REMARKS

Serial No. 09/808,686

For: PRECISION ELECTRIC MITER BOX

LETTER TO THE OFFICIAL DRAFTSMAN

Fig 1

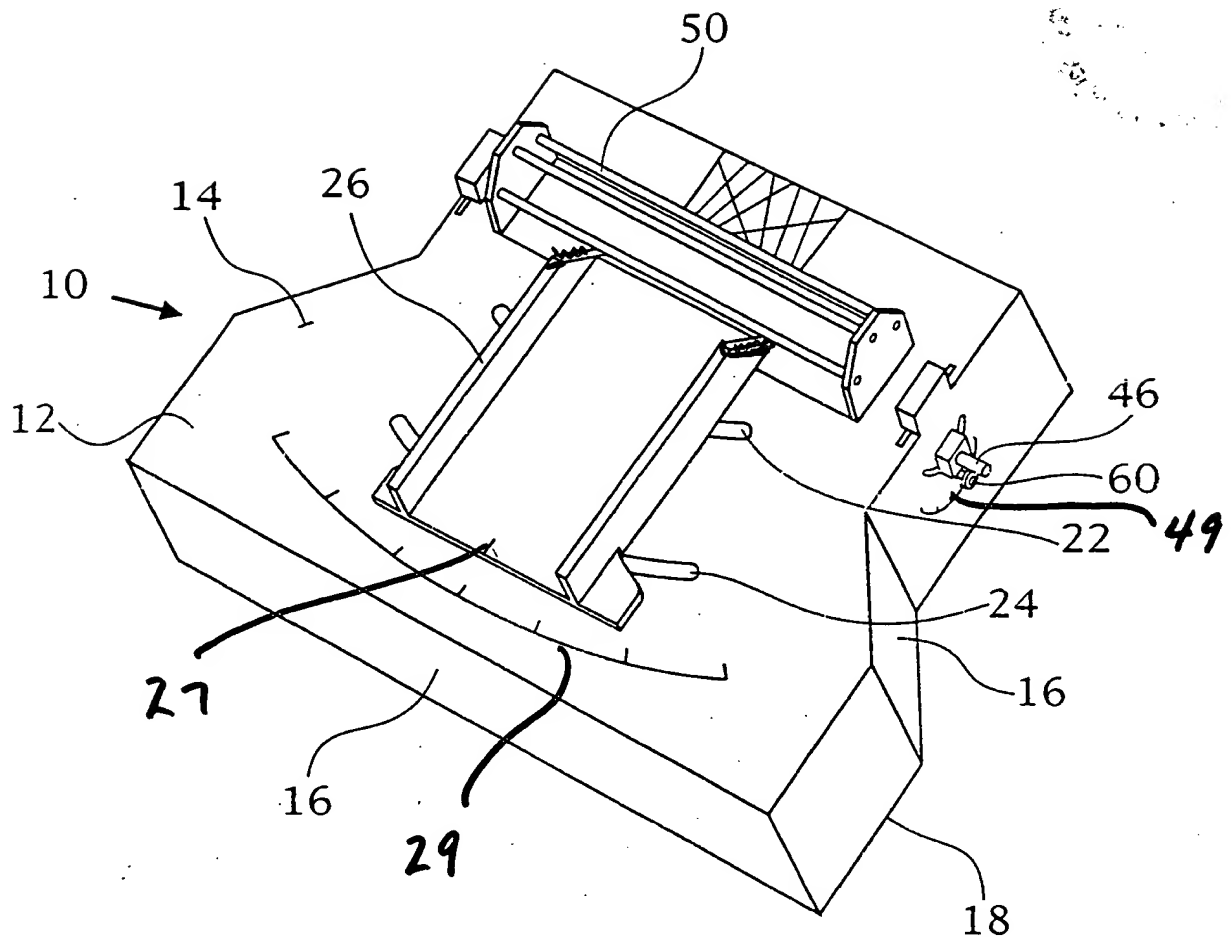
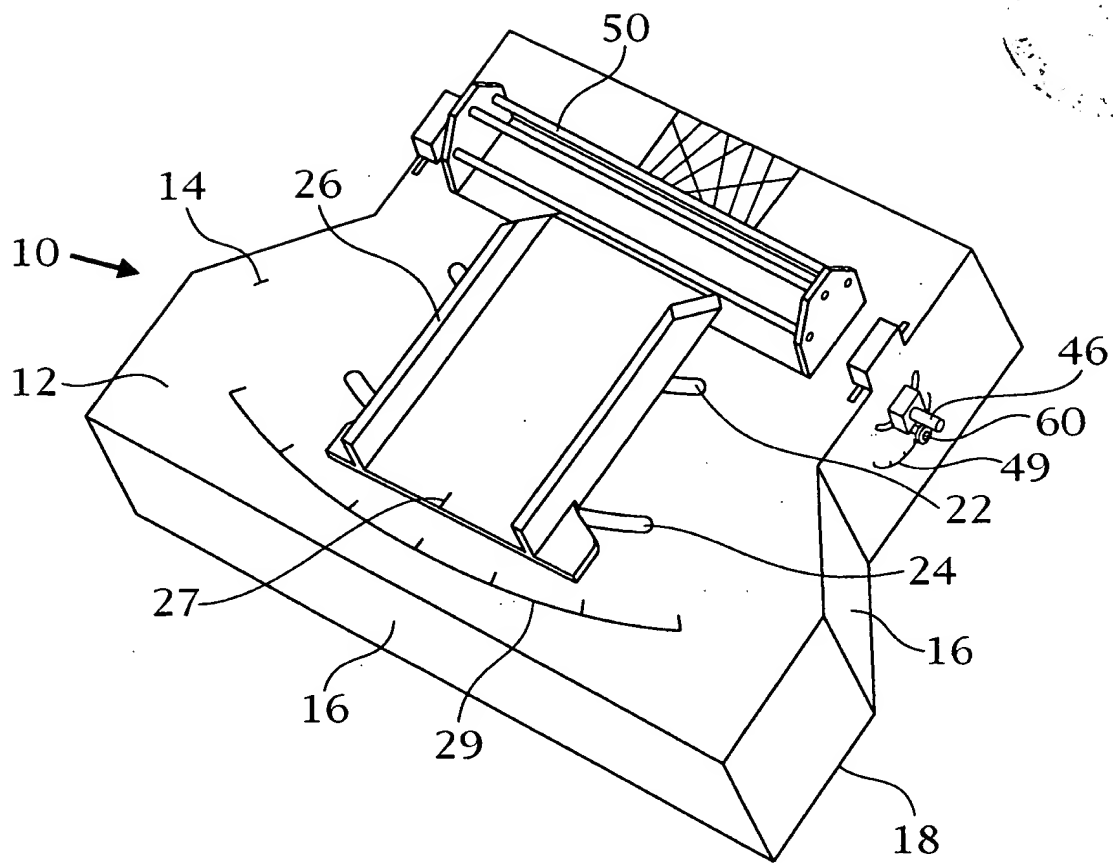
The drawings were objected to because of several informalities. The drawings have been corrected as shown in the red markings to add numerals or to correct numerals as suggested by the Examiner. In addition, it was noted that the work-holding member 26 did not accurately show the end near the elongated opening 20 having a slope downwardly toward the opening and also angularly from the outer portion toward the inner portion. Accordingly, FIGS. 1 and 4-9 have been amended. A duplicate copy of the red marked FIGS. 1, 3-11, 16, and 21-24 are enclosed to a Letter To The Official Draftsman. Also enclosed are formal drawings incorporating the corrections. Also, two sheets of drawings were submitted which included FIGS. 20-22. Please cancel the sheet of drawings which show FIGS. 20-22 and retain the sheet of drawings showing FIGS. 20-24.

Submitted herewith (in duplicate) for approval are proposed drawing corrections shown in red on the attached drawing copies.

Fig 3

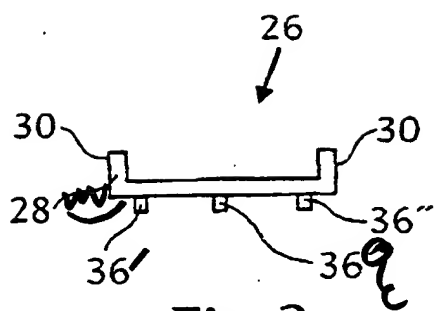
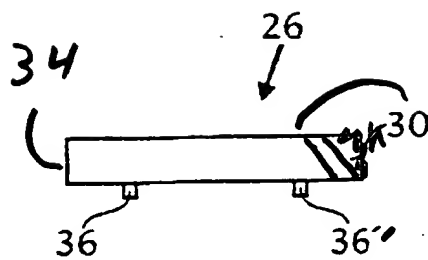
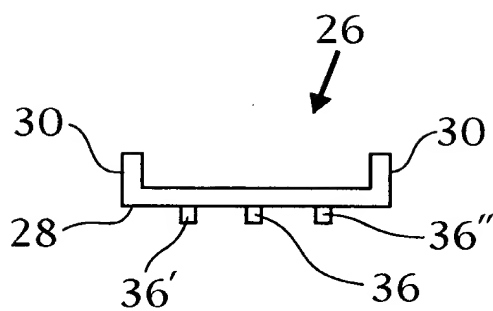
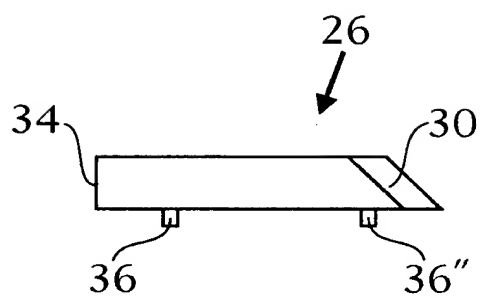
As shown in FIGS. 3-5 [3-4], a work-holding member 26 [20] has a channel shape with a base 28 and two opposite side walls 30 extending longitudinally on the base 28 between the first end 32 and the second end 34 of the work-holding member 26. The ends 32, 34 are open, having no walls formed thereon. In this manner a workpiece W may be disposed within the work-holding member 26 between the side walls 30 with the workpiece extending from the first end 32 or from both the first end 32 and the second end 34 as there is no restriction on the length of the workpiece W. The work-holding member 26 further has at least two protrusions 36 extending downwardly from the bottom surface of the base 28. The protrusions 36 [30] may be a peg or pin. One protrusion 36, disposed proximal to the second end 34 of the work-holding member 26, is received in the second curved track 24 on the top surface 14 of the housing 12. At least one, and preferably two, protrusions 36 are disposed proximal to the first end 32 of the work-holding member 26. If there are two protrusions 36', 36'', the protrusions are spaced apart. The protrusions 36', 36'' are received in the first curved track 22. If there are two protrusions, one protrusion 36' is received in one of the inverted "L" portions and the other protrusion 36'' is received in the other of the inverted "L" portions. In this manner, the work-holding member 26 is connected to the top surface 14 of the housing 12.

Fig 10

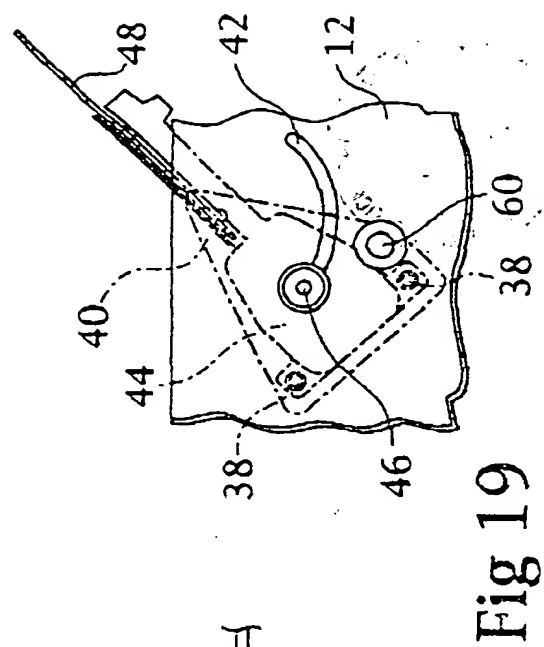
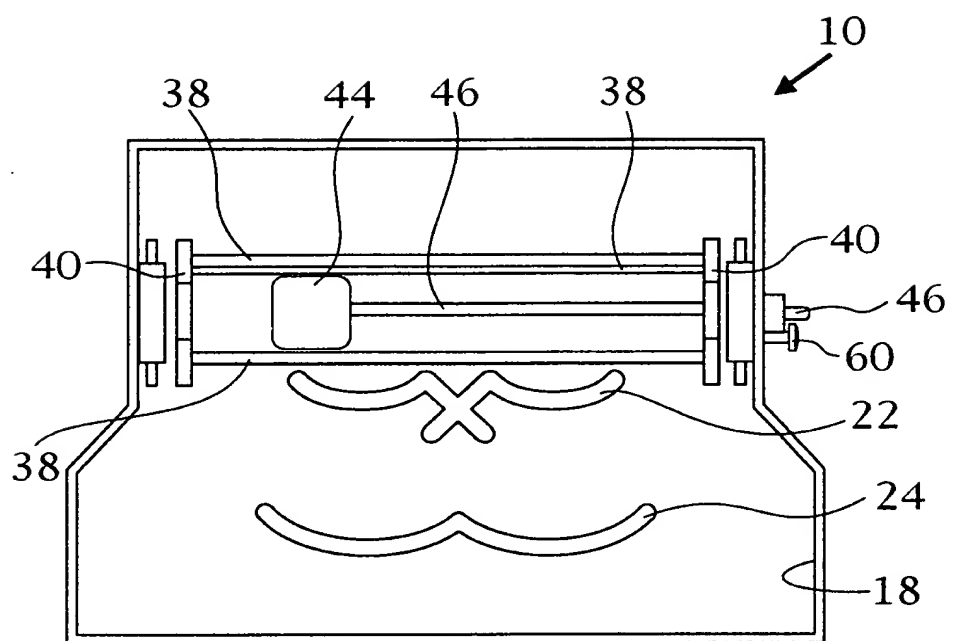
On the underside of the top surface 14 (FIG. 10), within the enclosure 18 [14], are a plurality of spaced-apart support means 38. The support means 38 are under, and approximately parallel with, the elongated opening 20. Preferably, the support means 38 are three rails each having a length greater than the length of the elongated opening 20. As shown in FIGS. 11-14, the opposite ends of each rail is mounted on a respective plate 40. Each plate 40 is pivotally connected to the housing 12.
